Independent Rapid Assessment of the Parramatta CBD Planning Proposal for DPE

1st March 2022

Bennett and Trimble

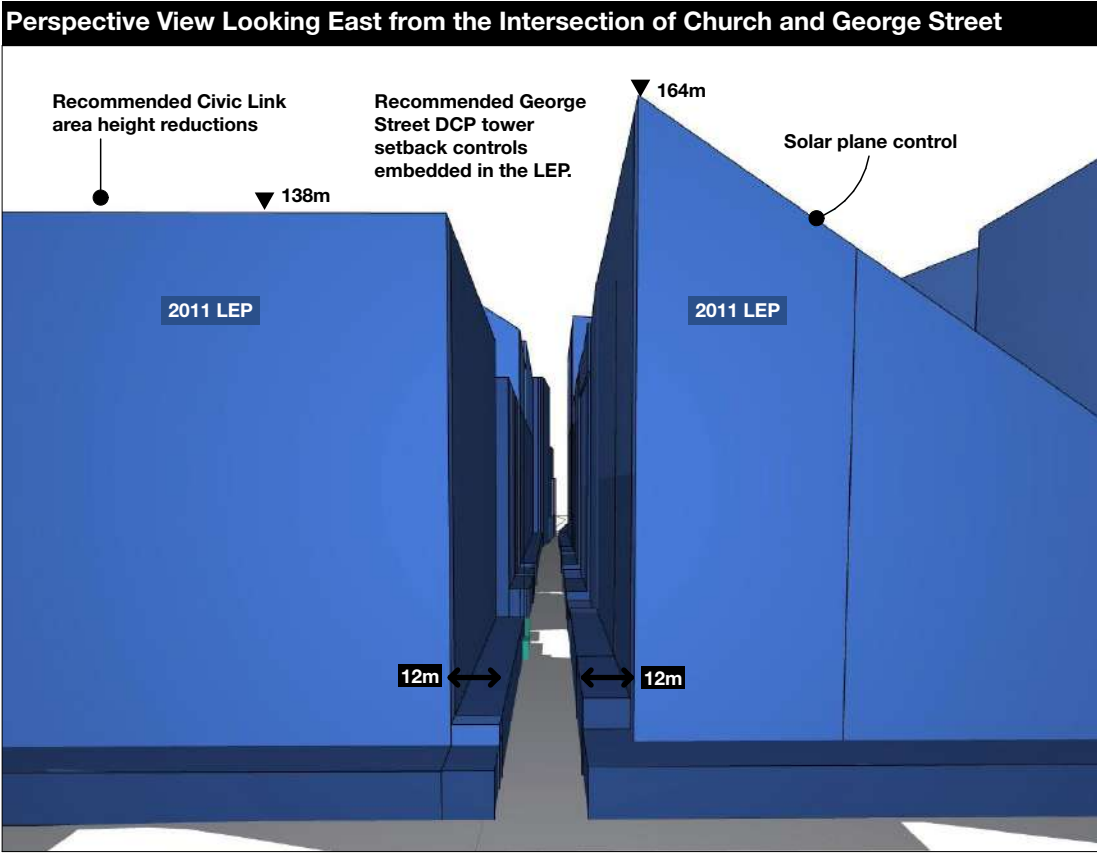
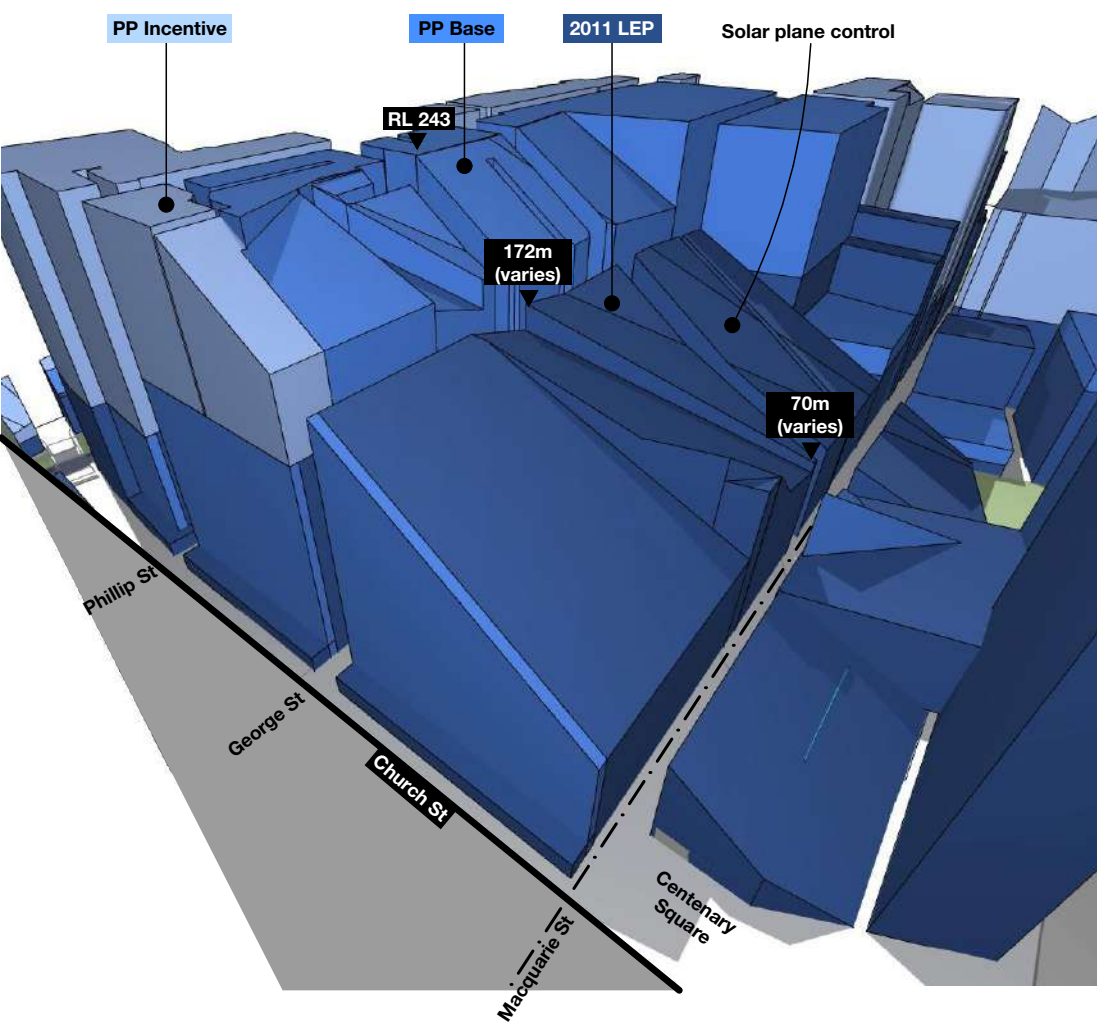
George Street was originally planned as 200 ft (60.96m) wide and was one of the primary axes in Parramatta's original town plan spanning between Government House and Queen's Wharf. The width of the street was reduced to its present 20m width in 1811 to accommodate an expanding population.

Embed the proposed DCP tower setback controls for George Street within the LEP to provide additional certainty in urban and built form outcomes and to ensure ongoing protection of this axis and view line.

Eastern Alignment

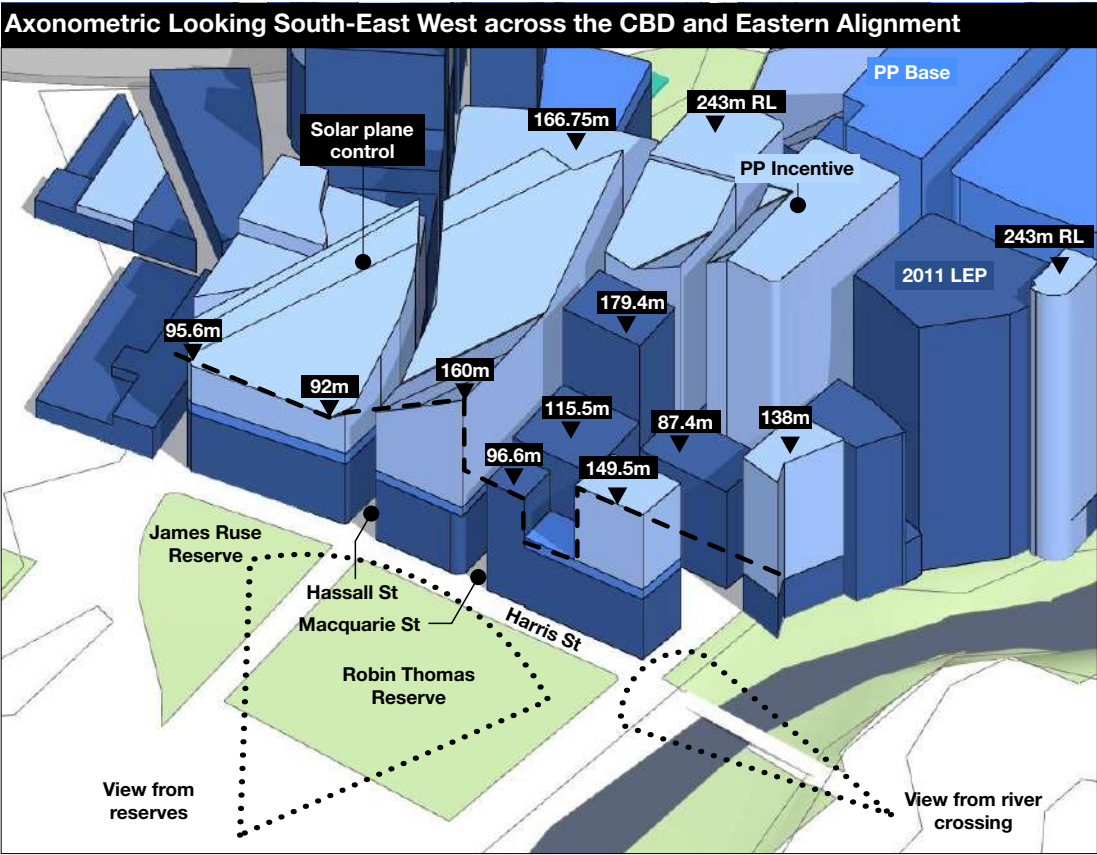
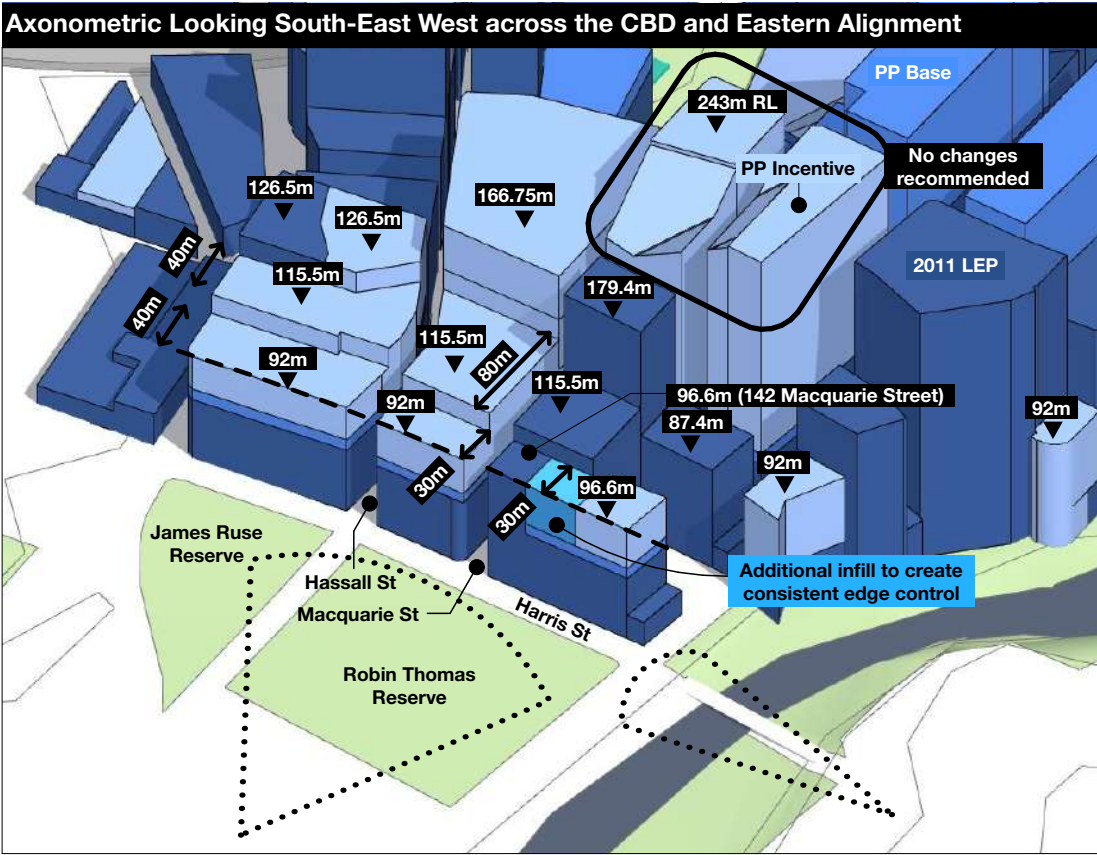
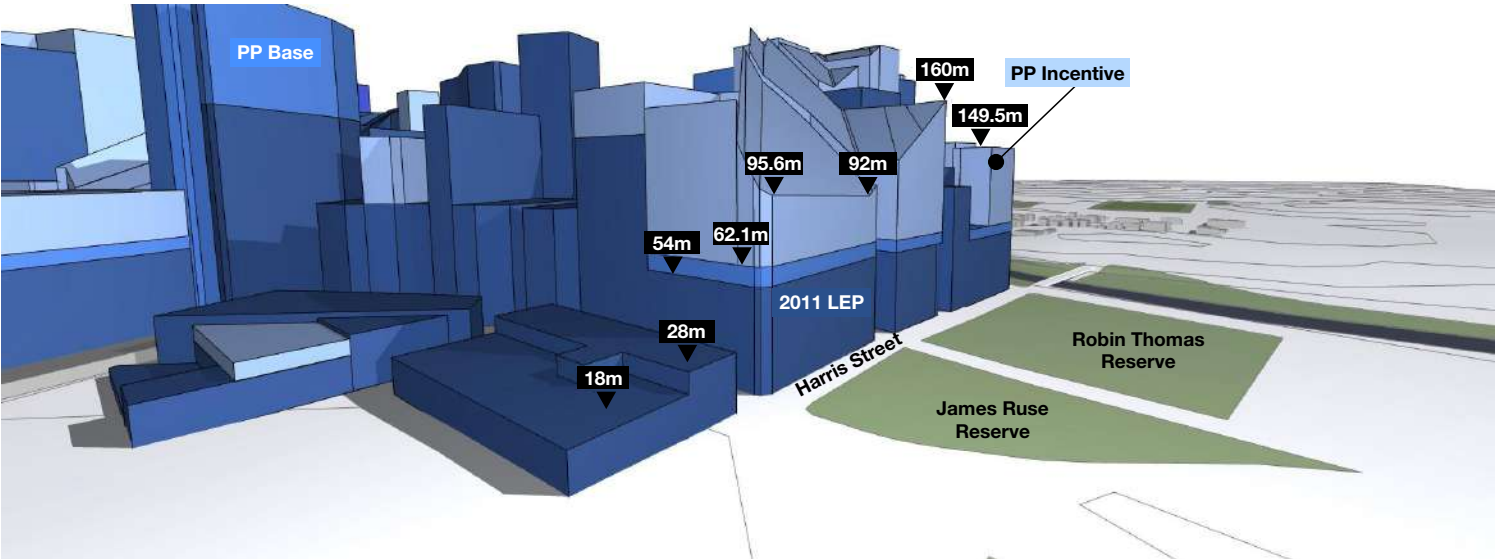
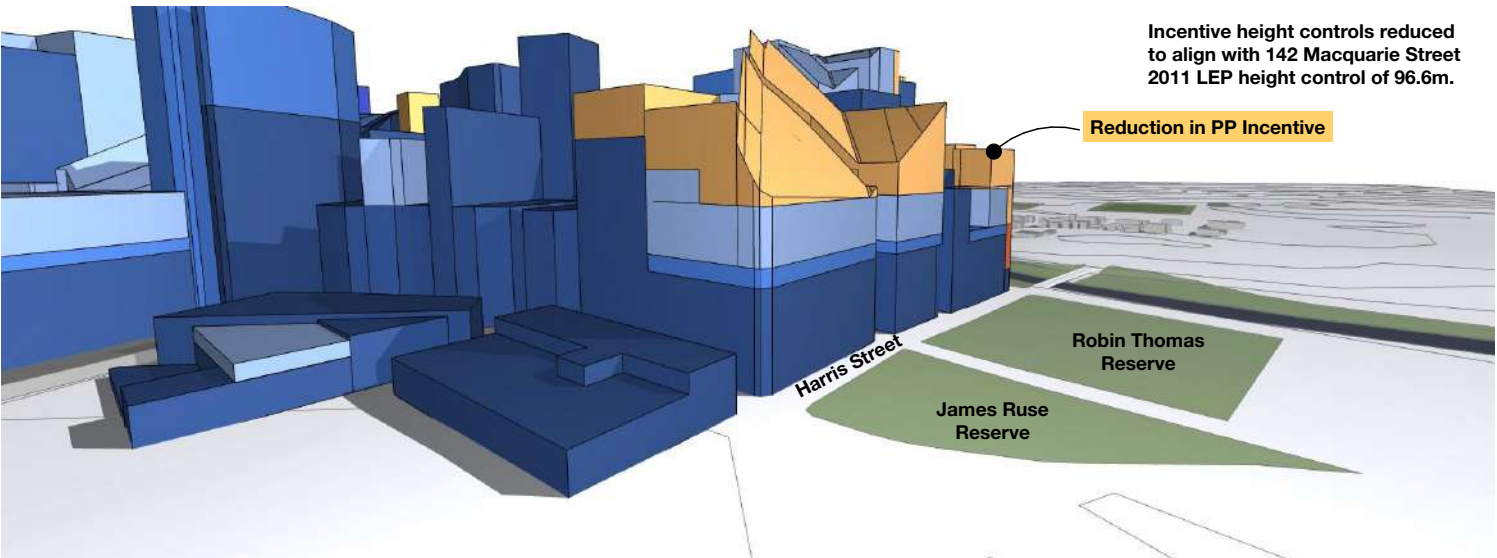
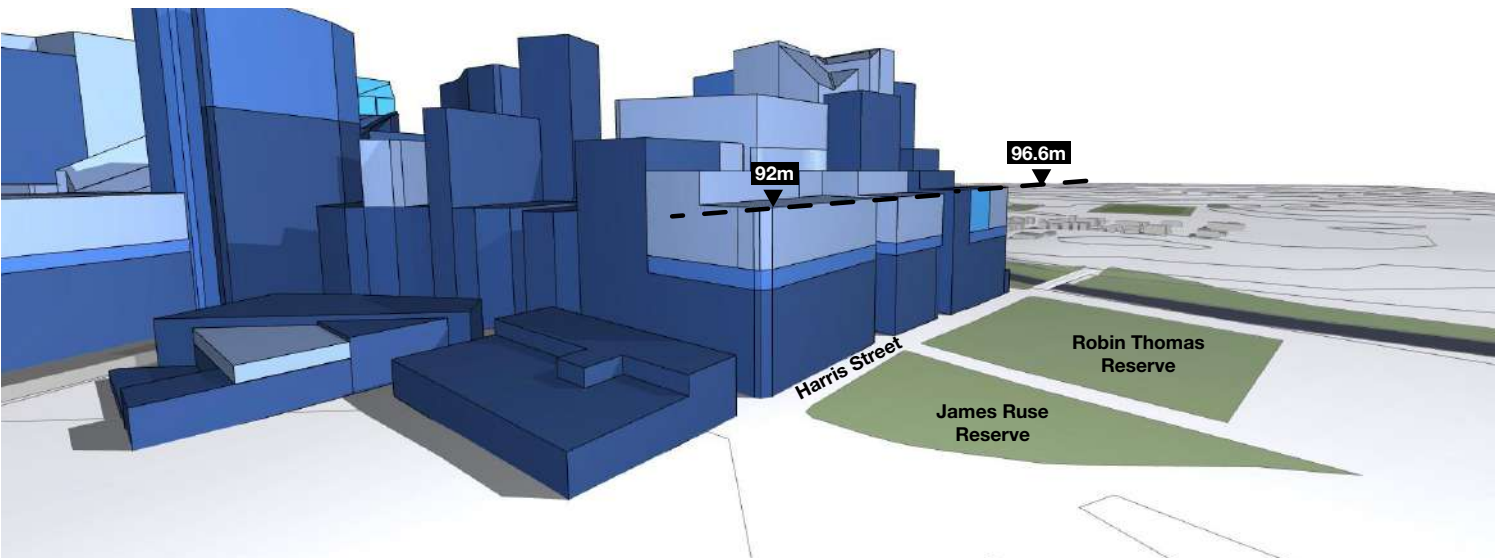
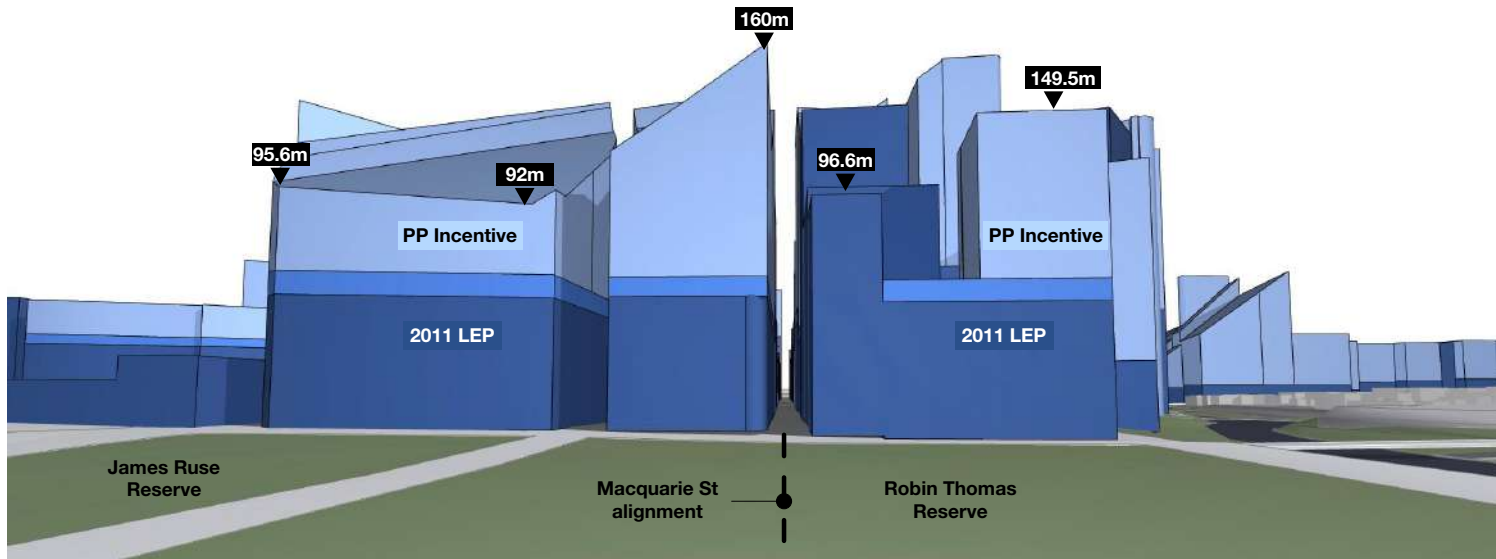
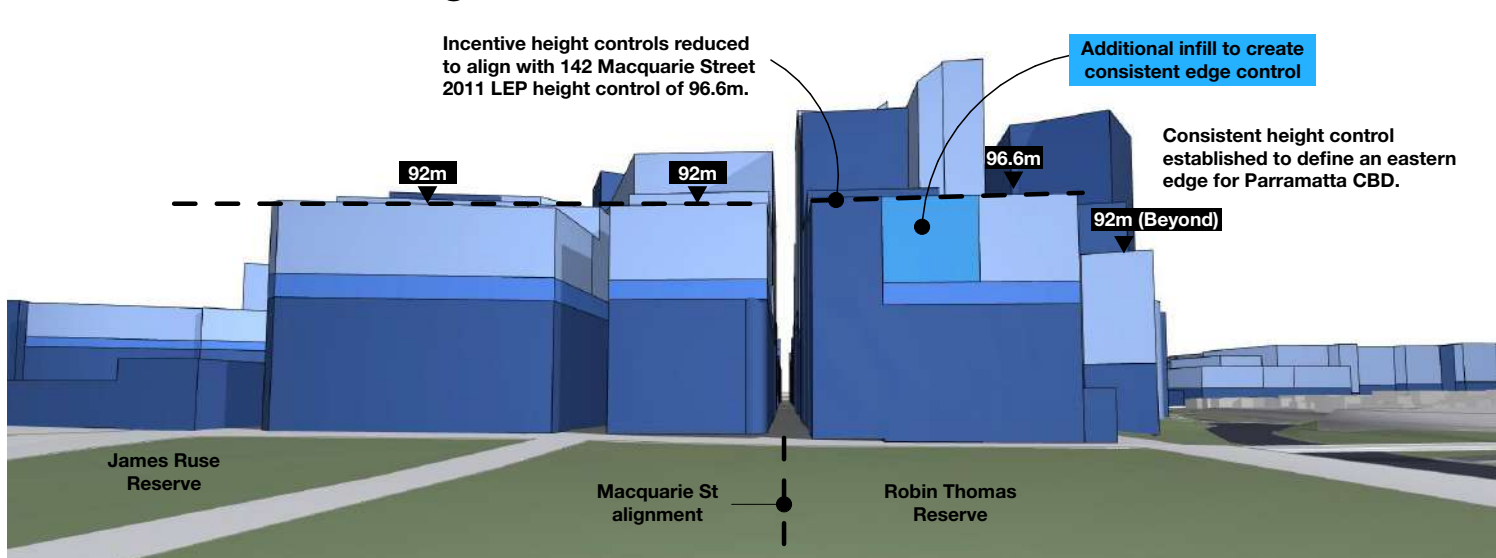
The proposed planning controls are the result of a number of intersecting solar planes and approved planning proposal envelopes. The resulting control envelopes and potential urban form is overly complex and does not acknowledge the significance of this alignment and the potential to establish a consistent and well considered edge between the city and the open spaces to the east.

The proposed height north of Macquarie Street should align with the approved planning proposal at 142 Macquarie Street which establishes a datum of 96.6m (inclusive of Design Excellence). This height is broadly consistent with the proposed heights for the Parramatta River foreshore and results in further consistency when viewed from the eastern approach along the Parramatta River. The height of Macquarie Street is set at 92m and is defined by the lowest point on the solar access plane.

Further consolidation and simplification is proposed for the height controls to encourage a rational series of stepped buildings as the blocks extend to the west rather than the overly complex geometries (established by the series of solar control planes) that would be permissible under the proposed controls.

Consider undertaking detailed studies for the Eastern Alignment to determine whether it can be included in the area recommended for approval. This would include overshadowing, FSR and heritage analysis, and the preparation of a height control plan.
